AGENDA PORTLAND PLANNING BOARD MEETING

To: Chair Mazer, Members of the Planning Board
From: Andrew Tufts, Planner
Date: May 7, 2021
Re: Proposed Rezoning: 160 State Street/99 Winter Street
Project ID: ZN-001021-2020
Meeting: May 11, 2021
CBL: 045 Coo4

Proposed Zoning Map Amendment

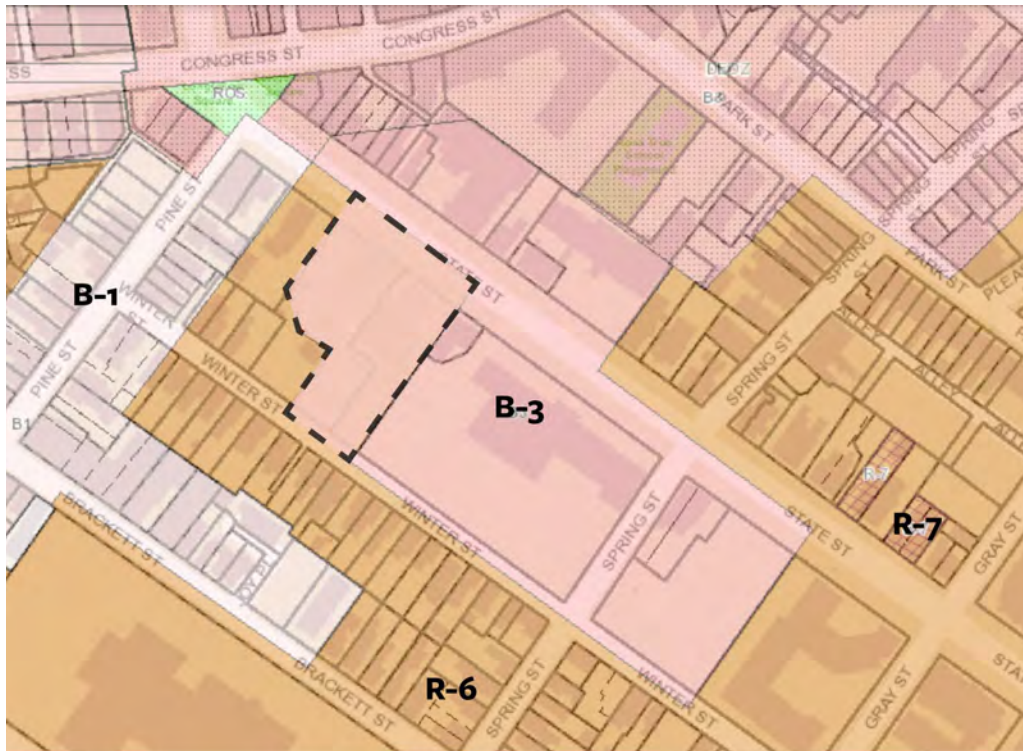
To maintain an appropriate height along Winter Street, staff recommend that the Downtown Height Overlay Map be amended within the proposed rezoning area to have a 35 foot height maximum to a depth of 65 feet from the parcel line fronting Winter Street and to map the remaining portions of the lots nearest State Street with a 65 foot height maximum. This would allow the Winter Street side to maintain a lower-scale while allowing the applicant to increase the height of a building towards State Street beyond the 65 foot step back area.

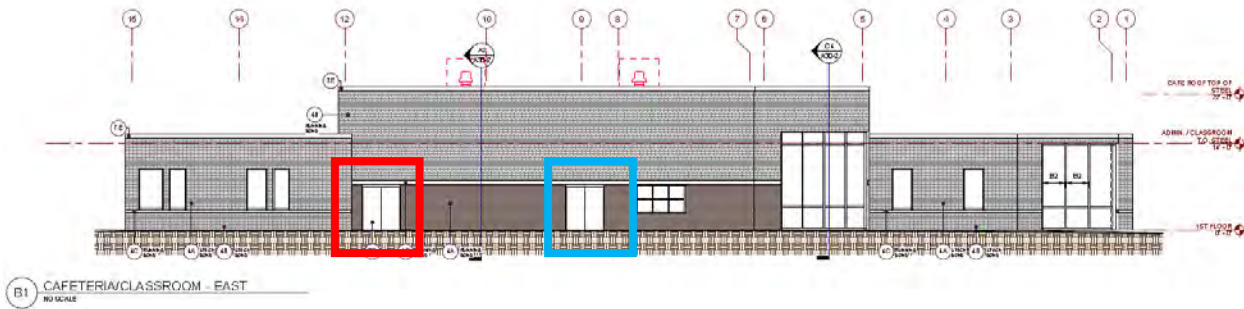
Figure 7: East elevation showing rear of the proposed addition, illustrating one area in question with potential for pedestrian traffic to spill from exterior door (on left) in red into the perimeter access lane. The entrance to the warming kitchen (on right) in blue is identified for reference to show where deliveries will occur.

Staff Comment: Staff have reviewed the proposal and find that the applicant has provided a number of features to the design to help improve the proposed conditions for safe and reasonable access and circulation for users of the site including a new sidewalk from Sherwood Street to the school entrance, and repaving, regrading, recurbing at the main drop-off area to meet accessibility guidelines, as well as adding new traffic signage and crosswalk striping.

Figure 8: Screenshot Site Plan with Aerial Showing Relocated Basketball Full Court

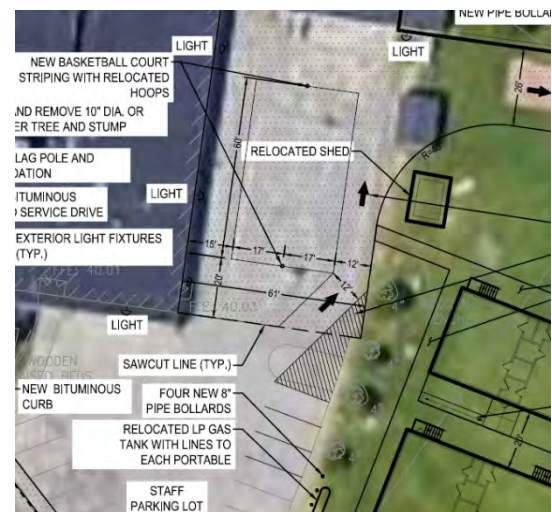
Recreation staff walked the site with Portland Schools staff on March 26th and found that the basketball hoops should be kept away from the building to the extent possible, both to minimize potential damage to the windows and for distraction to the children in the classrooms. Recreation staff do not support moving the basketball full court to the multi-use green space due to the limited number of large fields available in the area and the high use of the fields, which is currently used by various age groups. To reduce the impacts of vehicles within the proximity of the two-hoop basketball court, the applicant has proposed relocating the posts to within 15 feet of the school, as recommended by Recreation Staff and the school principal (See Figure 8). Three (3) feet of additional width of paved area and the turning radius curve has been enlarged to create a 12-foot clearance from edge of pavement to the court to help accommodate vehicles.

Recreation staff preferred to see as little of encroachment as possible within the playground area to the north from the relocated basketball half-court, citing: (i) there are equipment fall zones that could potentially be infringed upon which would result in non-compliance to playground standards and; (ii) a playground woodchip perimeter barricade under the hoop would be problematic, creating an obstacle for users attempting to safely use the recreational facility (Attachment 5). Therefore, keeping the single-hoop post away from the building and against the playground was determined to be necessary. To improve the vehicle circulation by the single-hoop basketball court, the applicant has agreed to pull the basketball post three feet closer to the playground curb, with pavement extended to give more space between the basketball court and turning truck traffic (See Figure 9). Staff finds that this helps to minimize obstructions and improves access for vehicles.

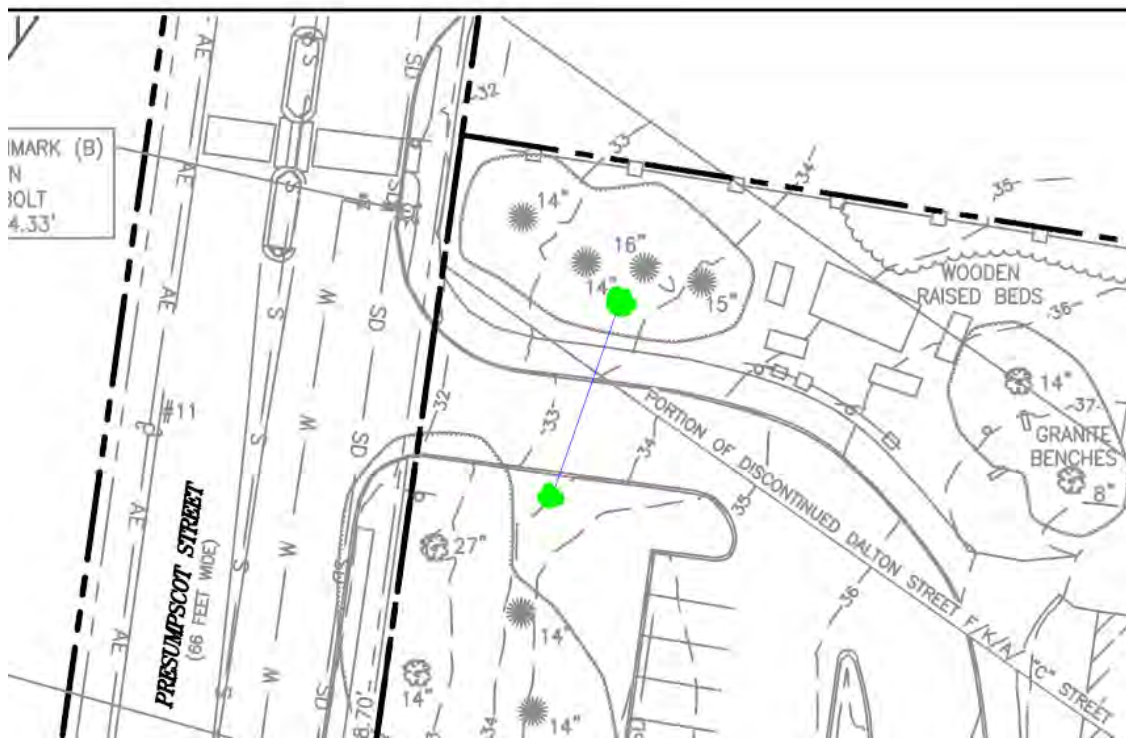
In order for the applicant to avoid needing a waiver, do you recommend adding 3 trees in the frontage (somewhere) to complete the uninterrupted 45' apart requirement? Below are locations I'm putting out there for your consideration, which are about 45' away from the next tree.

x1 added to south side of frontage

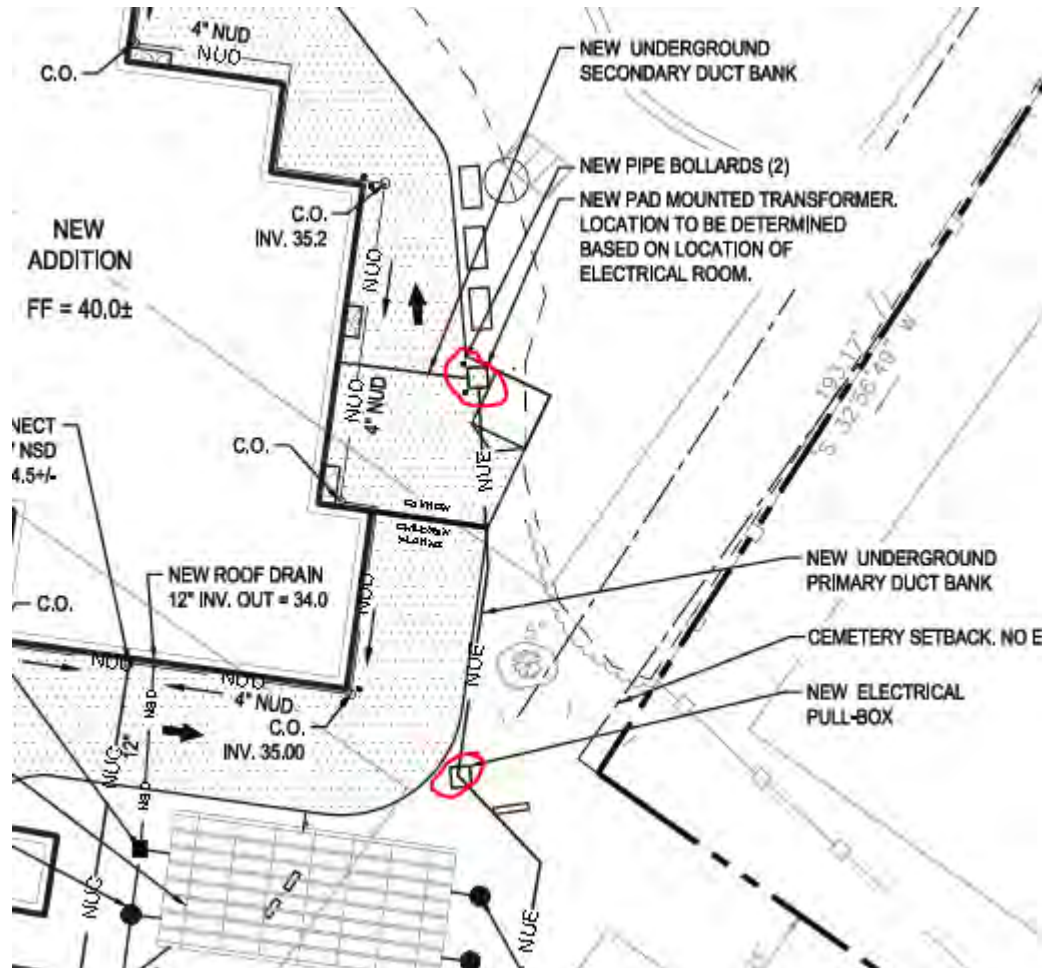
Hi Jeff, also, I'm not sure if the location of the electrical transformer now also circled in image below will change, but wondering your thoughts about screening that as well.

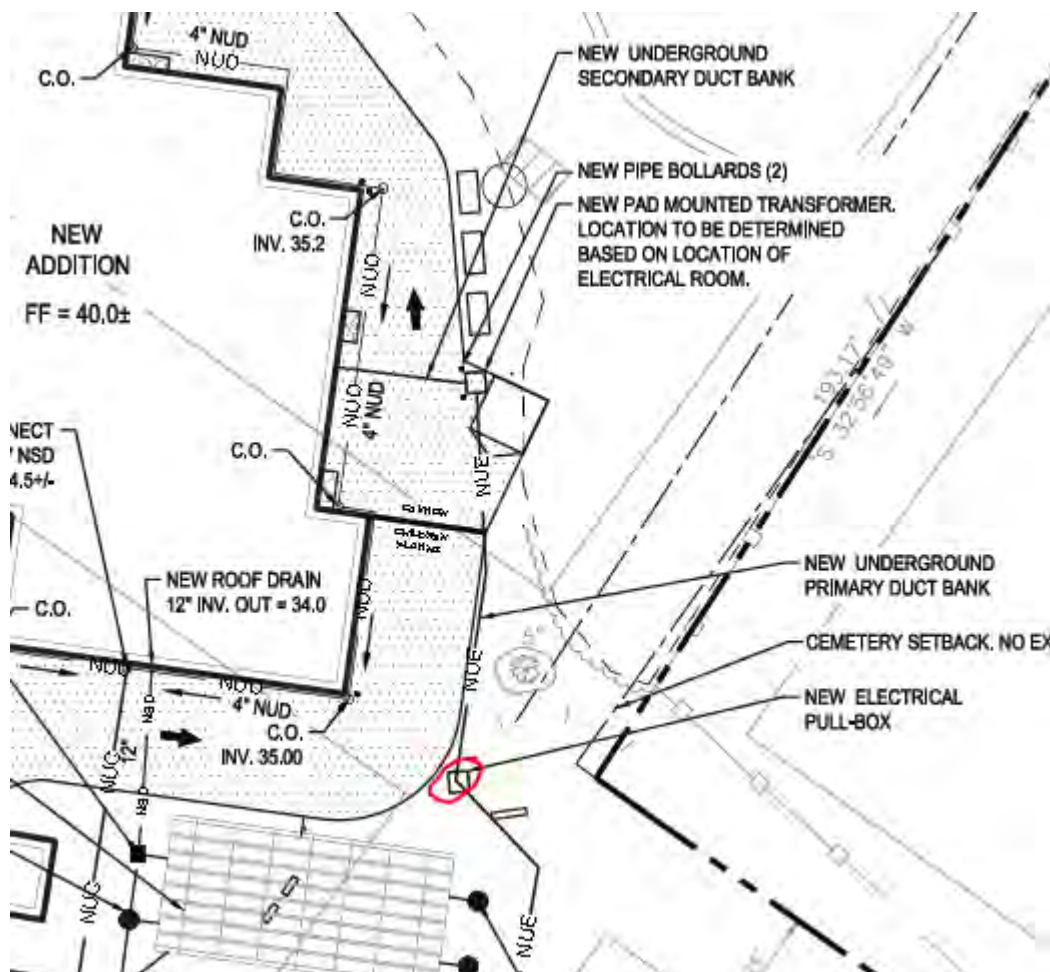
I do plan to have them show what screening they intend for a utility box at the rear of the property which is only shown on the updated Utility plan. Any recommendations on type of planting to screen this?
